Product Change Notification

ITT Cannon

PCN Number: PCN26003WN

192990-0350 - Trident Snap Together (TST) Plug 2-way
121587-0010 - Trident Flame Retardant (TFR) Plug 2-way

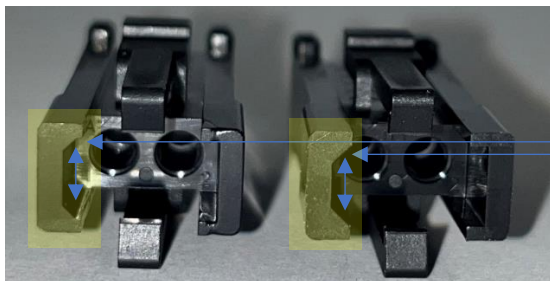
This letter is to inform you about changes we have already done in 2024. We have improved the profile/geometry of the connectors to eliminate incorrect mating.

There was a possibility of reverse assembly. The connector was possible to mate either way, even these connectors have a profile/geometry (see yellow marking) to ensure the plug and receptacle is mated the correct way.

Left side: Old version

Right side: New version with
corrected angle and longer slope.
